**UNITED STATES OF AMERICA
NUCLEAR REGULATORY COMMISSION
BEFORE THE ATOMIC SAFETY AND LICENSING BOARD**

| Holtec International |) | Docket No. 72-1051 |

**EXPERT REPORT AND *CURRICULUM VITAE*
OF ROBERT ALVAREZ**

Declaration of Robert Alvarez on the Holtec International Application for a Consolidated Interim Storage Facility License (Docket No. 72-1051)

Figure 3

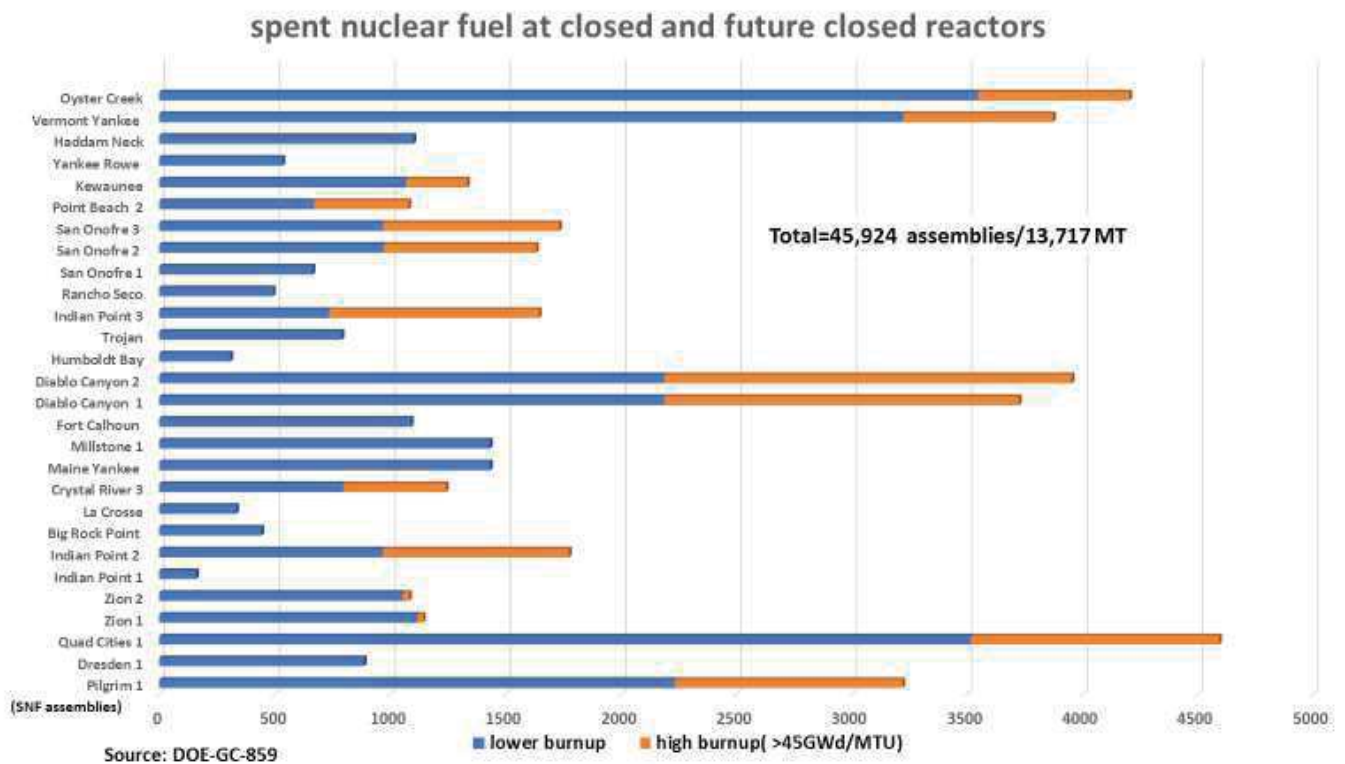
Approximately 23 percent of spent nuclear fuel at closed reactors and reactors expected to close over the next few years is high burnup (>45GWd/t) (see Figure 3). This is a significant issue because of the lack of data regarding the impacts on high-burnup spent fuel by transportation and multi-decade dry storage. The NRC and the nuclear industry do not have the necessary information to predict when storage of high-burnup fuel may cause problems. To err on the side of caution, high-burnup fuel might have to be left in cooling pools for 25 years—as opposed to the current three to five years for lower burnup spent fuel—to allow cladding temperatures to drop enough to reduce risks of cladding failure before the fuel is transferred to dry storage. Also, the cooling pools at US commercial reactors are rapidly filling, with more than 70 percent of the nation's 77,000 metric tons of spent fuel in reactor pools, of which roughly a fourth is high
